## Appendix 6

### FI LVIA Response

Project Title: **FI LVIA Response**

Document Title: **Appendix 6**

Figure 3-2 Map displaying the elevation of the Coole Wind Farm site and surrounding Topography features

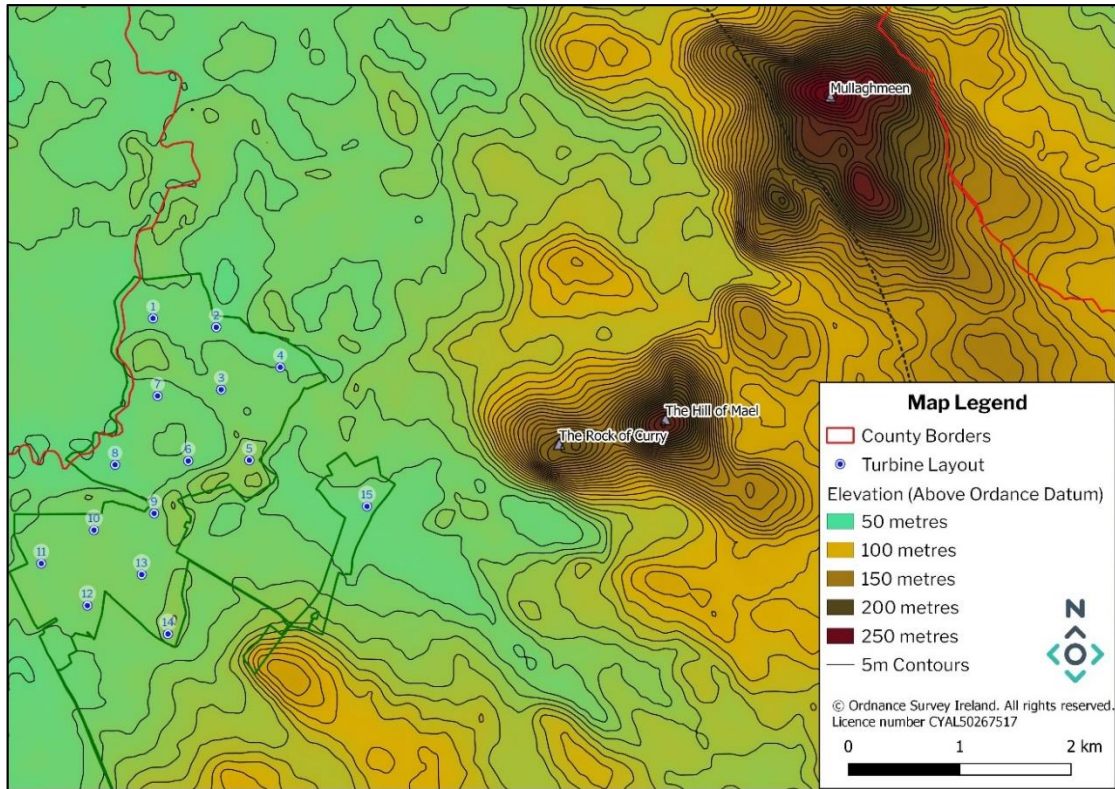
Several submissions address the scale of the proposed turbines within the photomontages in relation to local landscape features: One such submission states:

Figure 3-2 below shows the base elevation of the landscape of the Proposed Development site and the elevation of several topographical features surrounding the site to the east and north-east; the Hill of Mael, Rock of Curry and Mullaghmeen. Chapter 4 of the EIAR states each turbines foundation elevation, the table of elevations is replicated in

Table 3-1 below. The foundation elevation for Turbine 12 is the highest at 69m above sea level, combined with the turbine tip height this would give the turbine a height of 244m above sea level, 4 meters higher than the Hill of Mael.

Figure 3-3 Photomontage and Wireframe for VP05

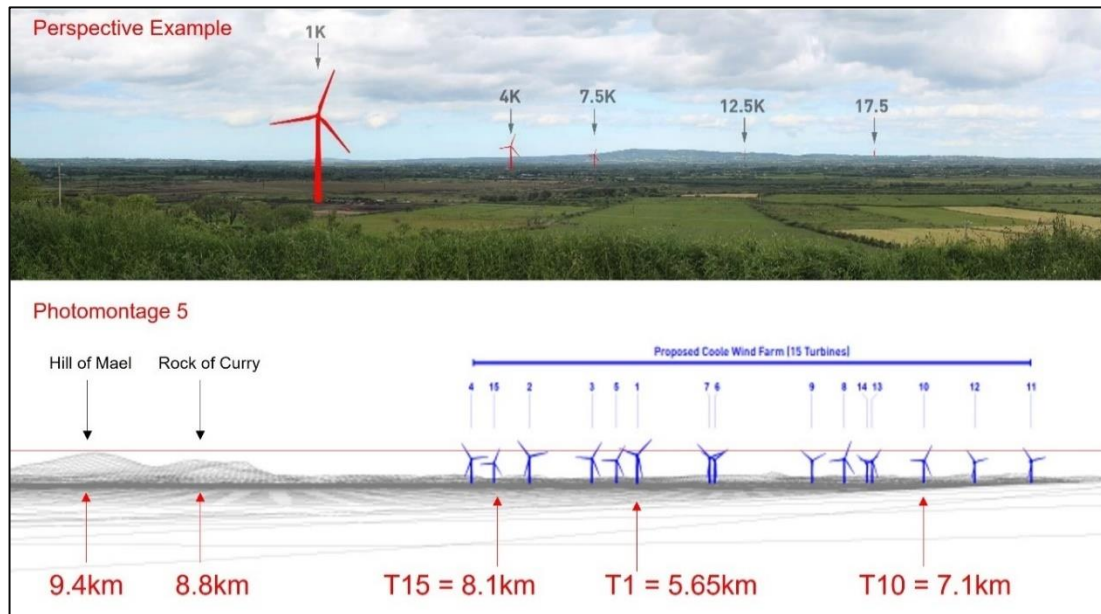
*“In photomontage no 5 the image comes from the townland of Ballywillan which overlooks the bogland and the beautiful Hill of Mael and Rock of Curry, two local landmark and some of the highest landmasses in the area. In this photoshopped Image the turbine are clearly visible in the landscape. They look to be almost the height of the local landmarks, tower above the bogland and break the otherwise unbroken skyline dramatically. This is bad enough. But this image is not at all accurate. Firstly the turbines themselves are 175m high situated on bogland 75m above sea level, making a combined total of 250m above sea level. The Hill of Mael is 240m above sea level. The turbines are to the fore of the Hill, therefore should appear larger than the hill. They do not Secondly the turbines are a light white–grey colour not a dull light brown as portrayed in these photomontage images. This makes them appear less distinct against the winter landscape in the background.”*

Figure 3-3 below shows the wireframe image extracted from Photomontage 05 of the Photomontage Booklet. The Hill of Mael and Rock of Curry are clearly visible as two topographical features to the left of the Proposed Development. From the perspective of Photomontage 05, the Proposed Development is located in closer proximity to the viewpoint than the Hill of Mael and the Rock of Curry, and therefore the proposed turbines are seen to be of larger scale. The red line indicates that the turbines full tip height does appear taller than the Hill of Mael. As stated previously the visibility of the turbines will decrease with the distance from which they are viewed. The closest turbine (T1) is approximately 5.65km from this viewpoint location, below in Figure 3-3 it appears relatively larger than T15 which is 8.1km away from the viewpoint. The Hill of Mael and Rock of Curry are over 8.5km away from this viewpoint and are both seen as smaller than the turbines.

Figure 3-4 Photomontage and Wireframe for VP10

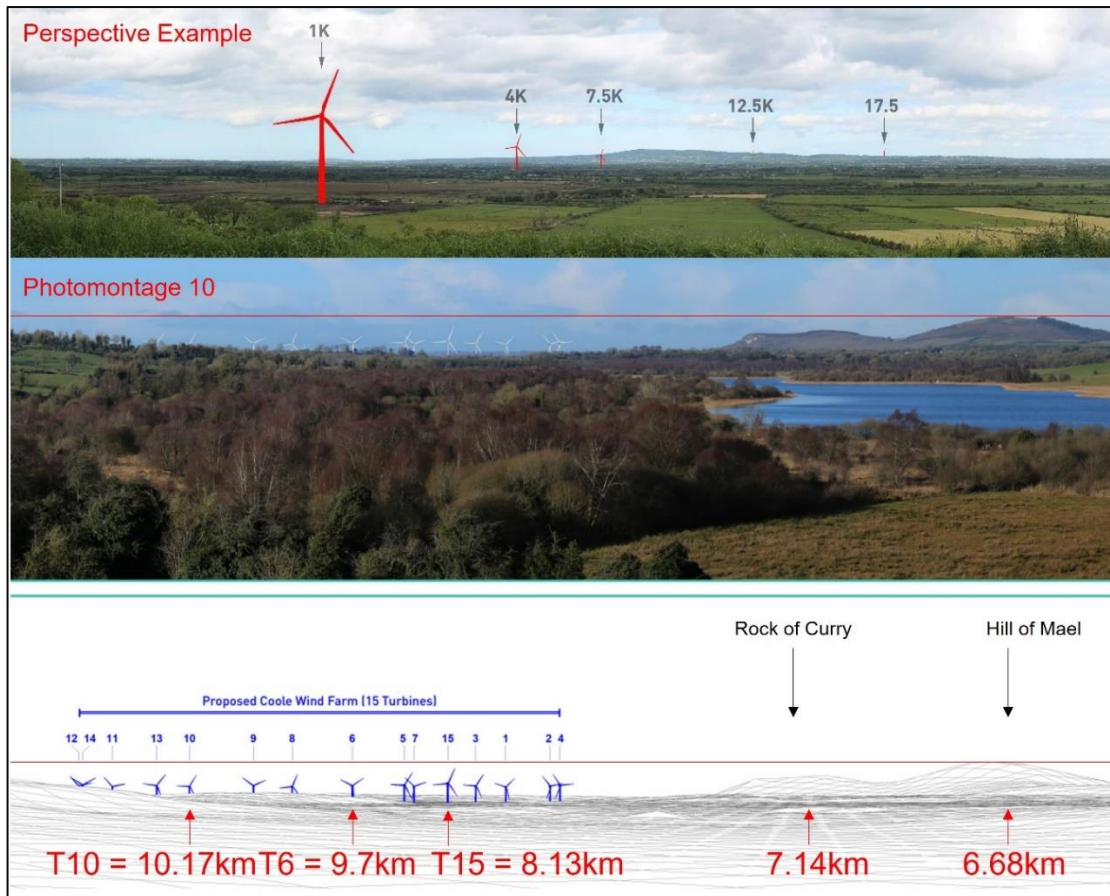
*“The photomontage 10 in Volume 2 Photomontage Booklet depicts the wind turbines in the same picture as the Hill of Mael on the left at 240m and Mullaghmeen on the right at 258m above sea level. The ground where Coole Wind Farm Ltd is applying to build the turbines is 75m above sea level so the tip of the blades will reach 250m above sea level. Thus they will be higher than the Hill of Mael and only 8m below the top Mullaghmeen which is not at all how the turbines are depicted as they are all lower than the Hill of Mael, Photomontage 10 is very misleading. This wind farm will dominate these two landmarks of North Westmeath.”*

Contrary to Photomontage 5, Photomontage 10 was taken from the east and so the Hill of Mael is located in closer proximity to the viewpoint location (6.68km) than the Proposed Development. The turbines are located further away from the viewpoint and so the Hill of Mael appears to be larger than the turbines. The closest turbine (T15) is approximately 8.13km from this viewpoint location and appears to be the largest turbine in Figure 3-4. It appears relatively larger than T1 and T10 which are over 10km away from the viewpoint.

Figure 3-5 Photomontage and Wireframe for VP21

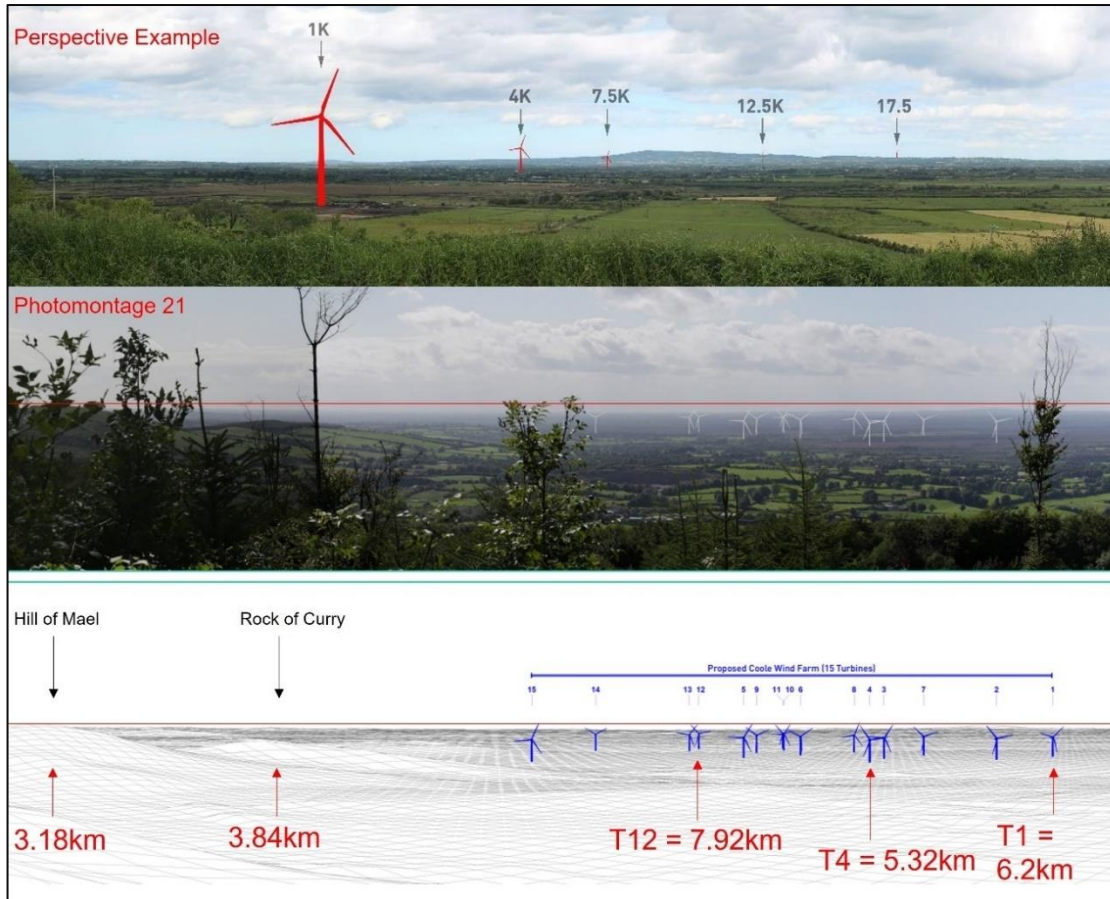
*“Photomontage 21 shows how the proposed Wind Farm will dominate the view from Mullaghmean and that is looking down on the turbines whereas they will actually be much higher. Mullaghmean is the largest beech forest in Ireland, a major tourist attraction with many walks all kept in very good condition. It is a very important community asset and so building adjacent to this is outrageous.”*

The location of VP21 is located 3.2km from the Hill of Mael and 5.32km from closest turbine (T4). Figure 3-5 below shows the photomontage and wireframe for Photomontage 21, the red line displayed in the Photomontage and wireframe show that, at full tip height, the turbines are taller than the Hill of Mael. The closest turbine (T4) appears largest as it is located 5.32k away from VP21, however T12, that is located 7.92km from VP21, appears shorter than T4.

Figure 3-6 Comparative wireframe for photomontage 7

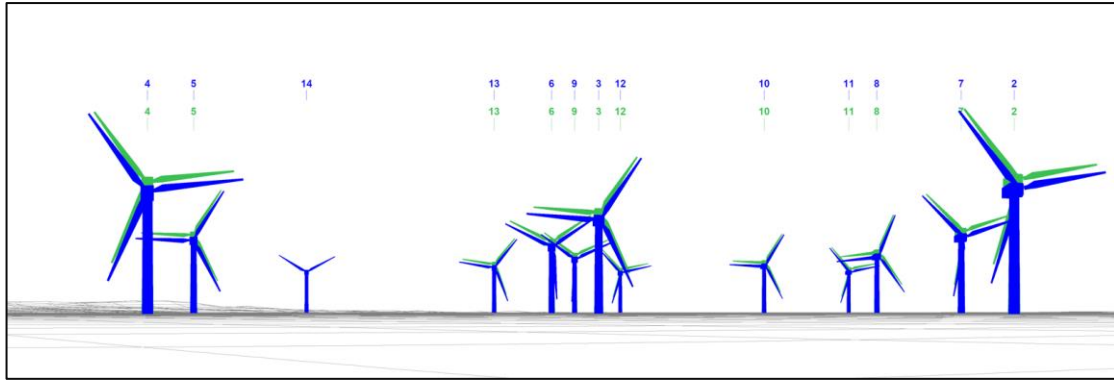
*“The photomontages are wrong and based on the narrower blade width turbines planned to be used for the non SID Coole Wind Farm. In the turbines planned for Coole Wind Farm SID 88.5% of the full turbine height consists of the diameter of the blade. The blade size in these images is based on the narrower turbine where 80% of the full height of the turbine consisted of the diameter of the blade. All of the photomontages are Inaccurate and do not show the full Impact of the turbines as the width of the turbines has increased by over 11 % from 140m to 155m in diameter. To prove my point take a look at any of the wire frame images. The 13 turbine Coole Wind Farm Images are drawn in green and the 15 turbine Coole Wind Farm images are drawn in blue. The proportions of the blades should have increased by over 11 % from the green to the blue wireframe images. They have not.”*

In relation to this critique, Figure 3-6 below shows a comparison of the wireframes of both turbine layouts for Photomontage 7. Both layouts have a turbine tip height of 175m. The hub height presented in the photomontages for the original 13 turbine layout for Coole Wind farm was 105m with a turbine blade diameter of 140m. For the new 15 turbine layout, the hub height presented in the photomontages was shorter at 97.5m but with a larger rotor diameter of 155m. As shown below in Figure 3-6, the turbines of the 13 turbine layout (represented in green) have taller hub heights than those of the 15 turbine layout (represented in blue). The blade length of the 15 turbine layout (blue) are longer than those of the 13 turbine layout (green) giving both turbine layouts the same full tip height of 175m.

Figure 3-9 ZTV of area surrounding VP08.

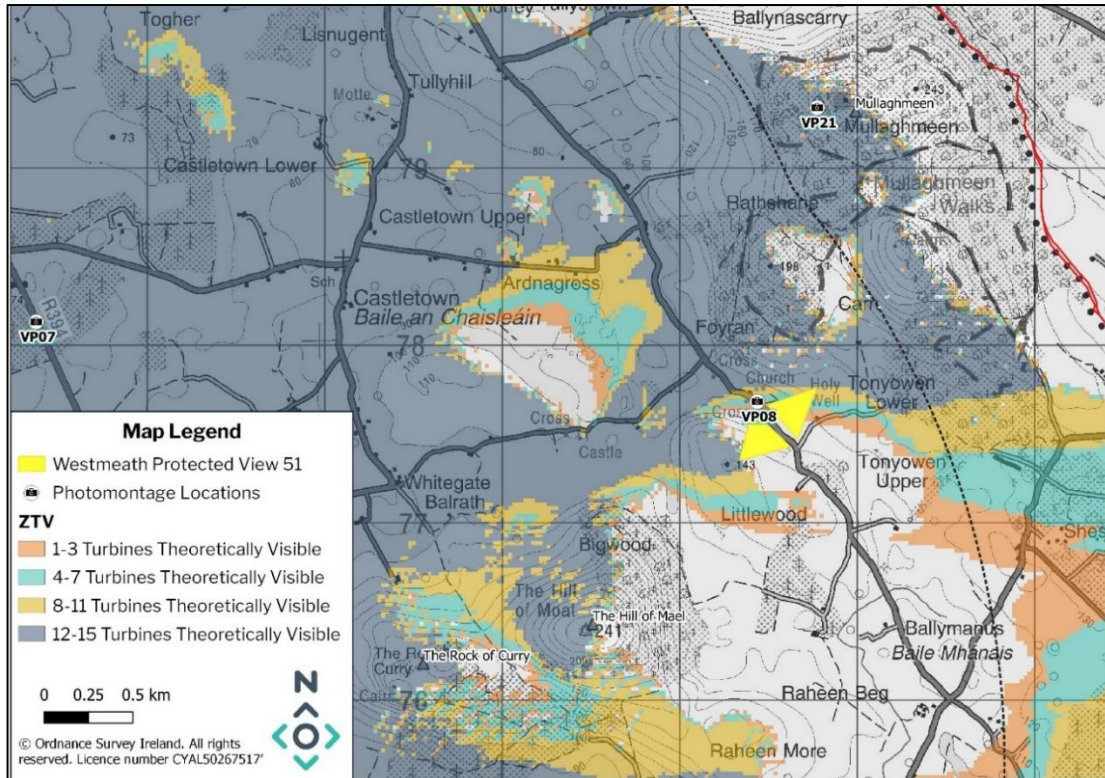
In relation to a concern highlighted in a 3<sup>rd</sup> Party Submission that “*Photomontage no 8 is not taken in the actual location of Protected View no 51, but in the vicinity of the view, this is highly inaccurate and deliberately misleading.*” The WCDP 2014-2020 describes Protected View 51 as ‘*Sporadic views (both sides of roadway) of “Hill of Mael” to the west and “Mullaghmeen” to the north-east from Local Road L-1759 which runs through the intervening valley.*’ Figure 3-9 below shows a map of Protected View 51 and the photomontage location with zones of theoretical visibility. The ZTV indicated that there was no visibility along a large portion of the section of the L1759 Local Road designated as part of the Protected View. VP08 is the closest point to this Protected View where there is theoretical visibility. Protected View 51 is directed towards the Hill of Mael and Mullaghmeen (as stated in the description from the WCDP) and not in the direction of the proposed turbines. Further south along the view from VP08, the Hill of Mael screens the turbines from view.

The new county development plan WCDP 2021-27 acknowledges that there are limited views from this scenic view due to vegetation. The WCDP 2021-27 describes Protected View 51 (re numbered to Protected View 32 in the new WCDP) as ‘*The focus of this view is the Hill of Mael and Mullaghmeen on either side of the road. It should be noted that there are stretches of the road which have no clear line of sight due to tall road-side vegetation.*’

Figure 3-10 Residential Receptors within 1.55km of a proposed turbine

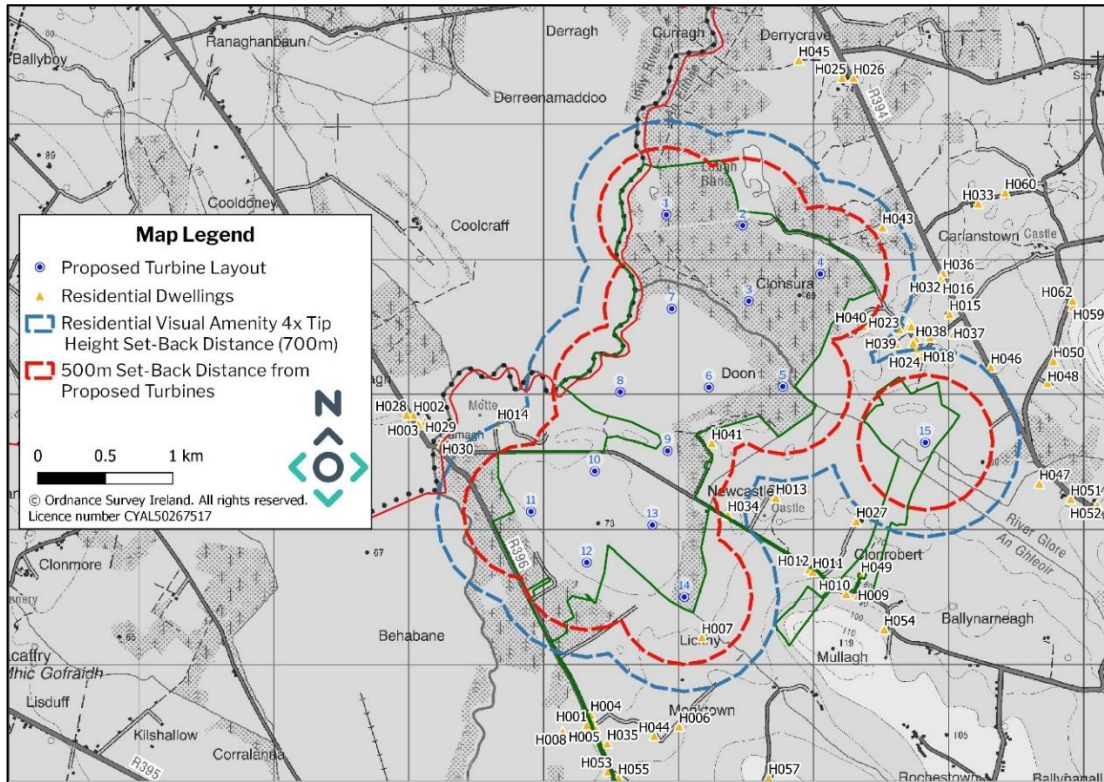
A number of 3<sup>rd</sup> party submissions raise concerns relating to the residential dwellings in close proximity to the site. These concerns highlight the setback distance set out by the Draft Revised Wind Energy Development Guidelines (2019, DoHPLG) for visual amenity. Potential for impacts on sensitive residential receptors has been kept to the fore throughout the iterative design process adopted for the Proposed Development and has been considered in full within the EIAR. The Draft Revised Wind Energy Development Guidelines (2019, DoHPLG) contain Specific Planning Policy Requirements (SPPRs). Of specific relevance here in relation to appropriate setback distances is SPPR 2 which states:

Figure 3-10 above displays a map of the residential receptors within 1.5km of a proposed turbine. As stated in Chapter 5 (Population and Human Health) of the EIAR “There are 18 no. occupied dwellings

located within one kilometre of the proposed turbine locations. The closest occupied dwelling H14 (i.e. dwelling not involved with the Proposed Development) is located at a distance of approx. 700 metres from the nearest proposed turbine T11. There are two dwellings, H18 & H24 which are located at distances of 638m and 679m from T15 respectively however these are individuals involved with the Proposed Development.” As stated above all occupied residential dwellings comply with the mandatory setback distance of 500m. Any other dwellings within the set-back distances area are either commercial/agricultural dwellings (H041 and H040) or derelict (H043, H034, H07). Therefore, it is emphasised (as stated within the EIAR) that the Proposed Development is compliant with the required set-back distances for residential visual amenity.
